P802.1CB Layering Issues

Norman Finn Cisco Systems

Rev 2, May 20, 2015

Issue with P802.1CB D1.0

Figure F-6 Ladder Redundancy

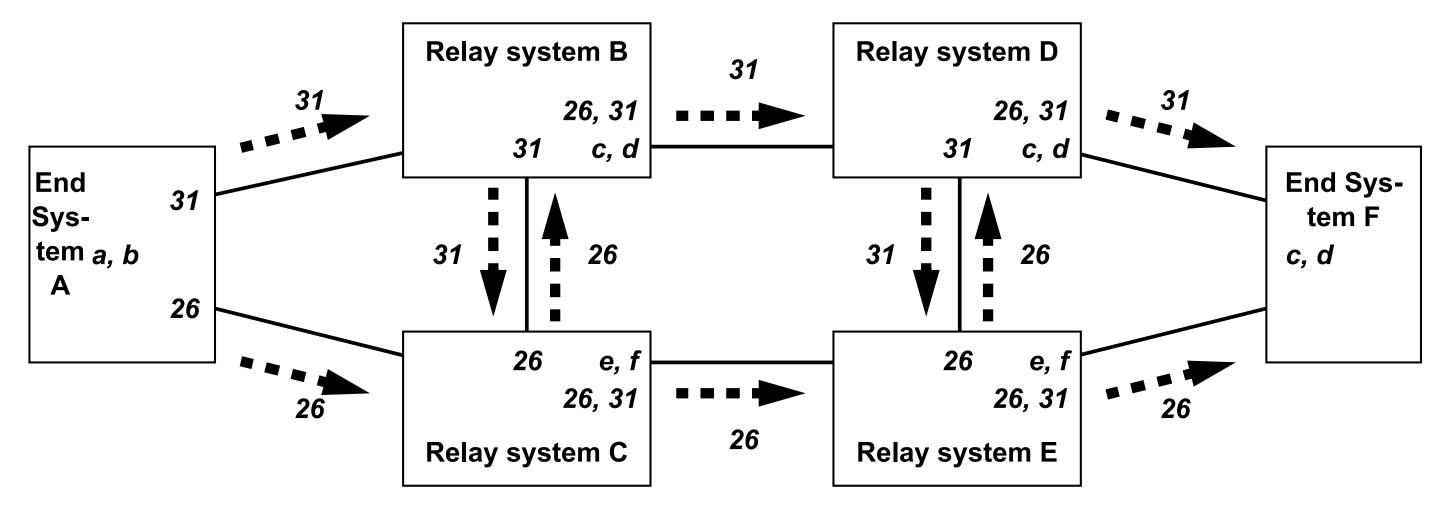
Current diagram for ladder redundancy

Figure F-6 Ladder Redundancy

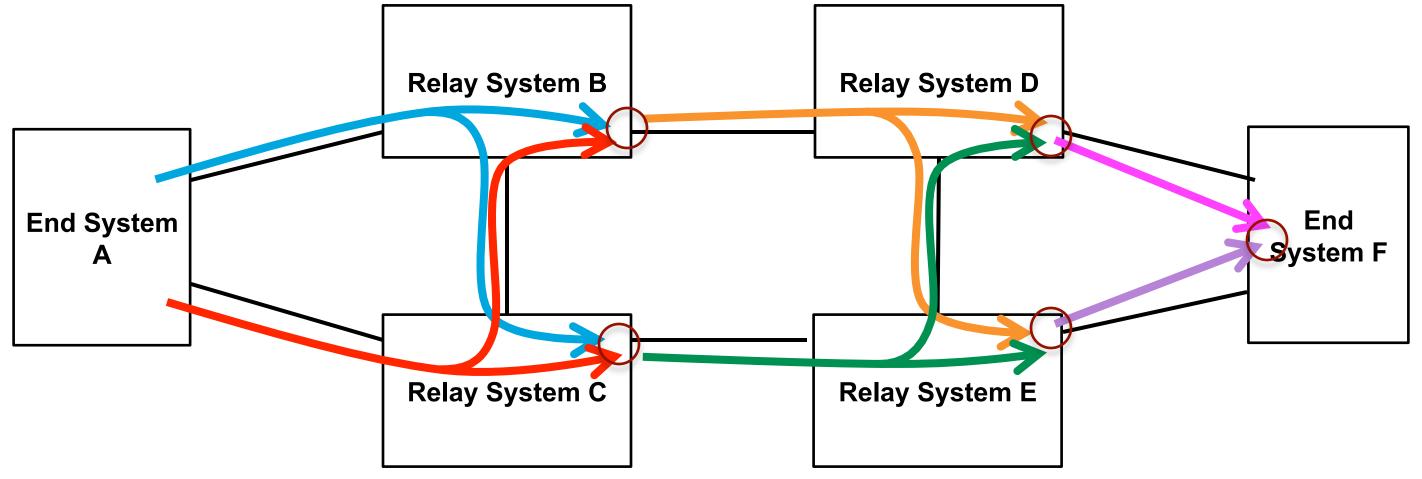
Perhaps a better diagram for ladder redundancy

Figure F-4—Protocol stack for relay system F in Figure F-1

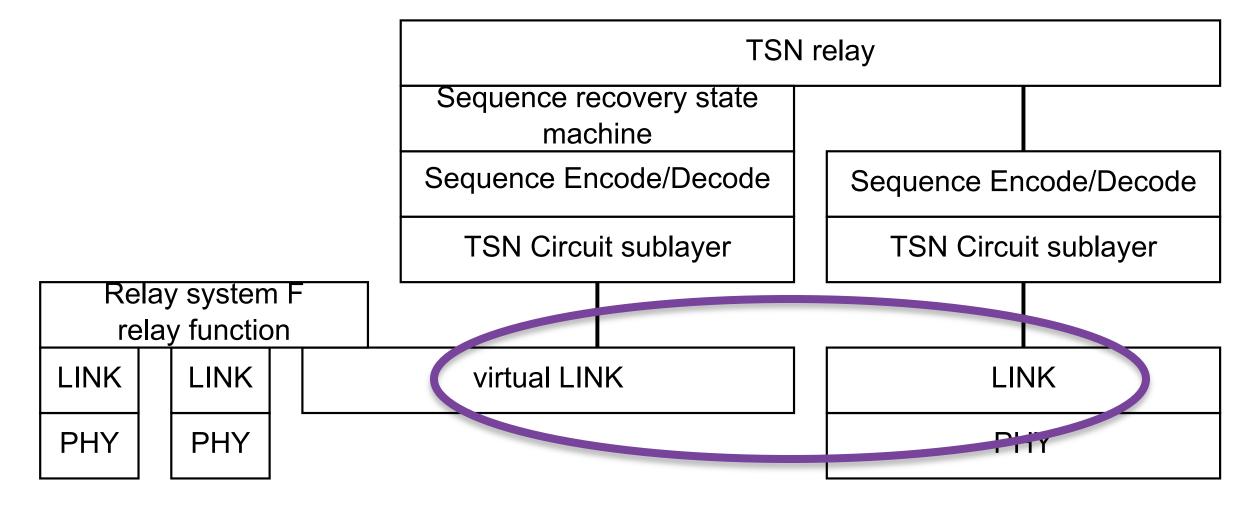
Problem: Where is the non-TSN traffic in the "TSN relay"?

Where is the non-TSN traffic?

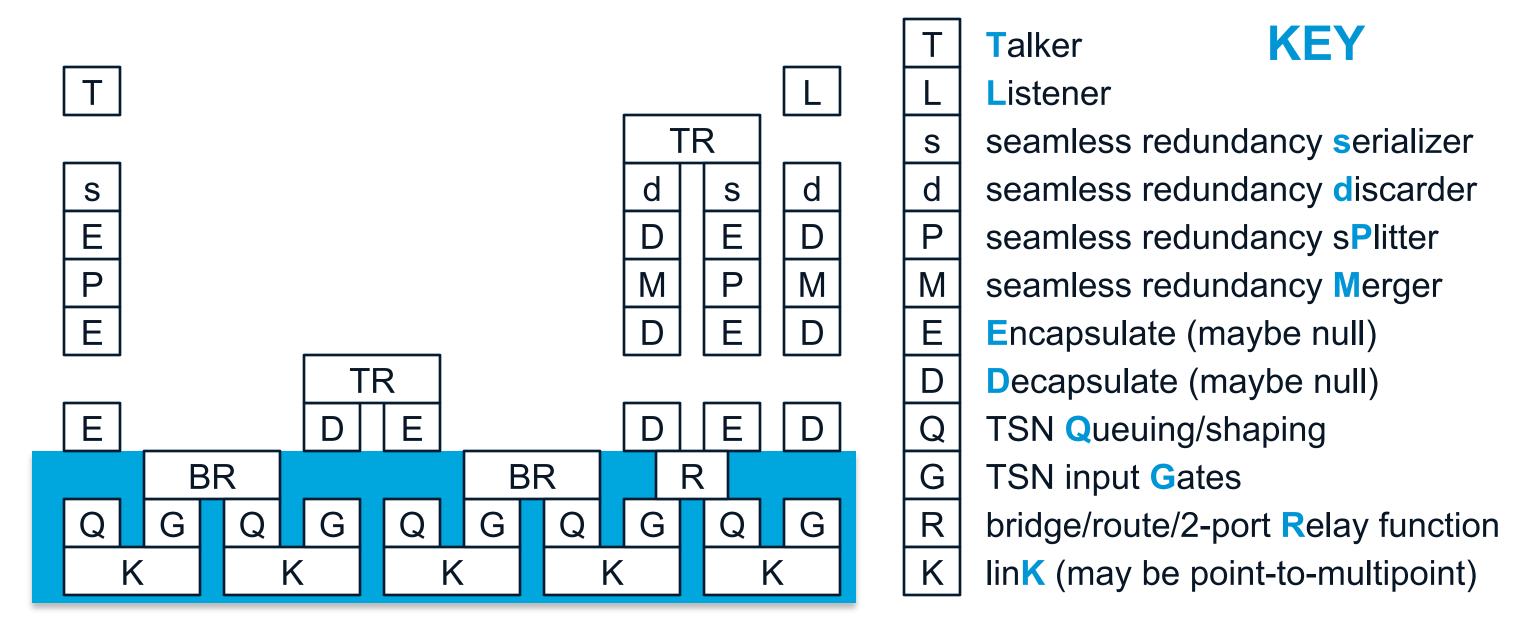
One answer: A Non-TSN relay keeps the non-TSN traffic where it belongs.
